Product Change Notice (PCN)

PCN Number: PCN-0451202R-01

Product(s) Affected: *PJ-057A*

PREVIOUS CUI DEVICES DETAIL / IMAGE	NEW CUI DEVICES DETAIL / IMAGE

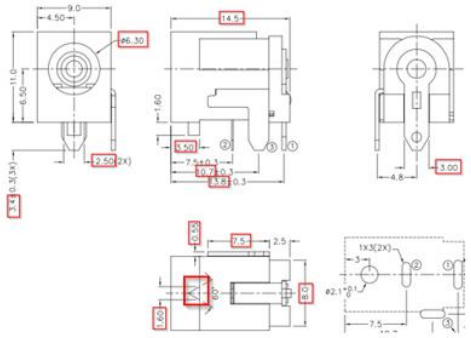
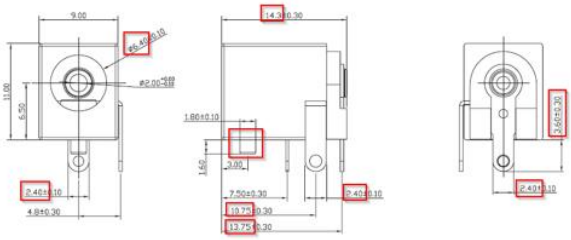
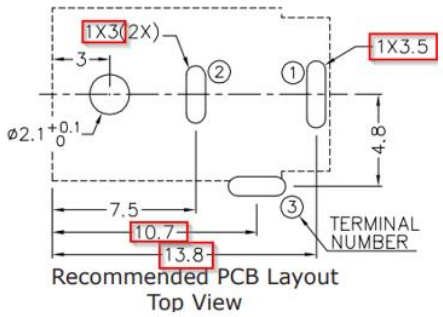
Description of Change: *Minor Housing and footprint differences. Material Change on the housing and terminals. See image Below*

PREVIOUS CUI DEVICES DETAIL / IMAGE	NEW CUI DEVICES DETAIL / IMAGE

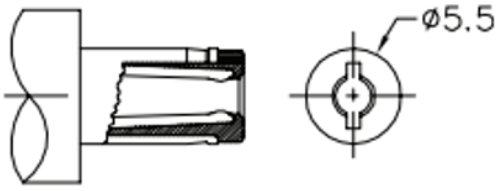
MATERIAL	PLATING
center pin	copper	nickel
terminal 1	brass	silver
terminal 2	copper alloy	silver
terminal 3	brass	silver
plastic	PBT

DESCRIPTION	MATERIAL	PLATING/COLOR
center pin	brass	nickel
terminal 1	brass t=0.40	silver
terminal 2	bronze t=0.30	silver
terminal 3	brass t=0.40	silver
cover	PA10T (UL94V-0)	black
housing	PA10T (UL94V-0)	black

MATING PLUG
Jack Insertion Depth: 9.15 mm

MATING PLUG
Jack Insertion Depth: 9.45 mm
